P 29442
A Repair

SEWAGE DISPOSAL SYSTEM
MARYLAND STATE DEPARTMENT OF HEALTH*

ADDRESS 6513 Route 29, Columbia, Md. 21046 PHONE 997-8210

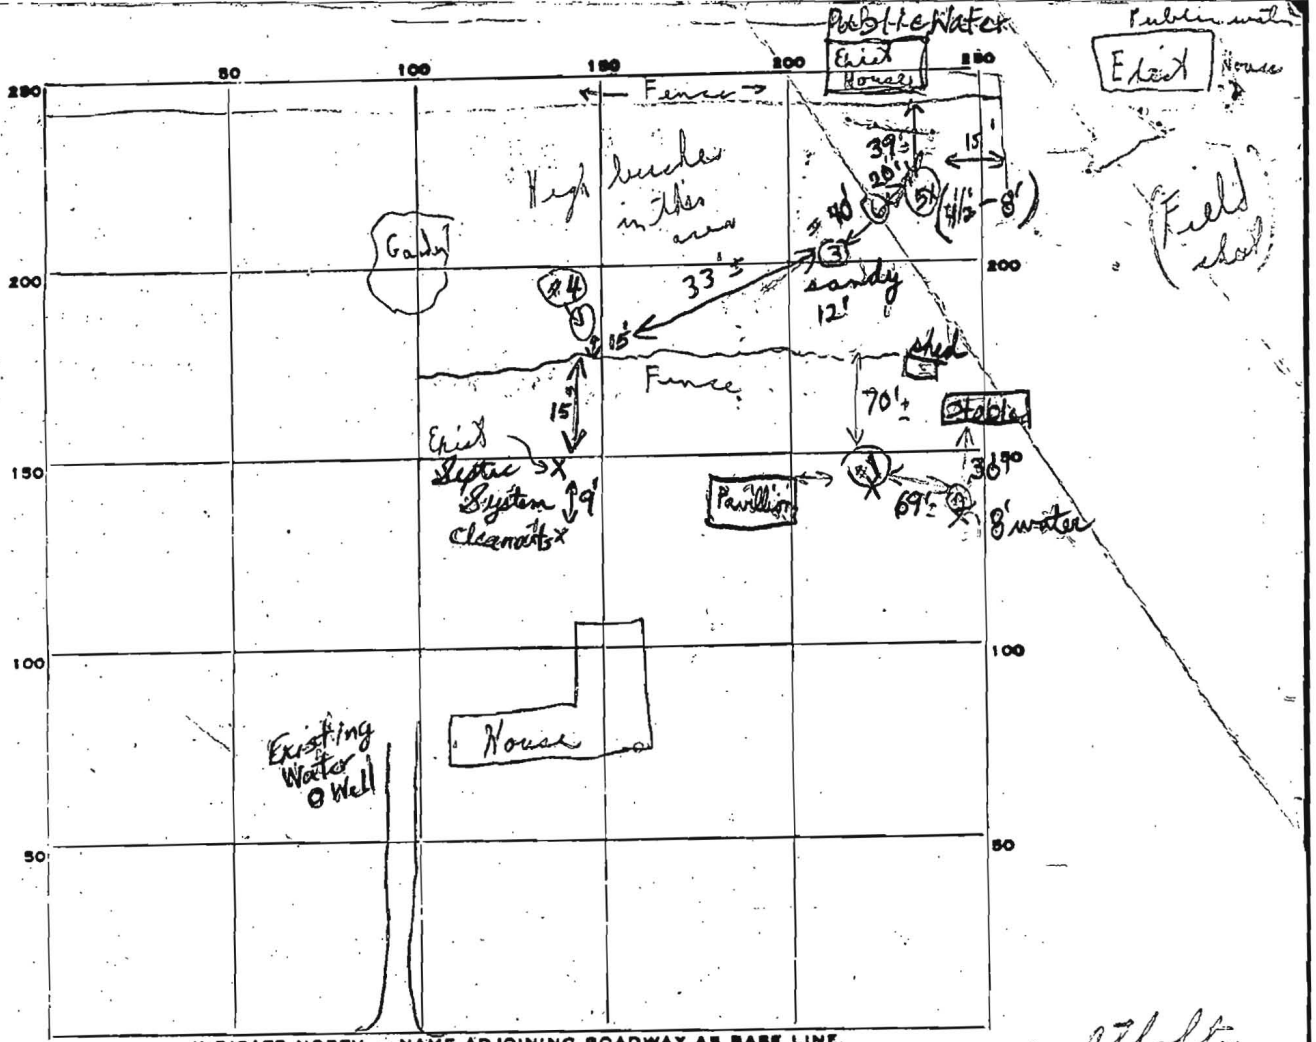
5/3/79 Checked - system behind

existing house - recommend drainall directly behind existing system hole # 4. See graph ↑

REMARKS 5/3/79 Resin pipe (1) existing plumbing in house note saw holes - soil below
Put system in area of #4 about old
5/3/79 #2 hole water; #1 hole 12 1/2' water, 3 holes - sandy loam
#4 hole 4'-12 1/2' sandy loam; #5 hole 4 1/2' - 8' rock
#8 hole 4' - 4 1/2' sandy loam to 10'

7/6/79 - OK to cover work.
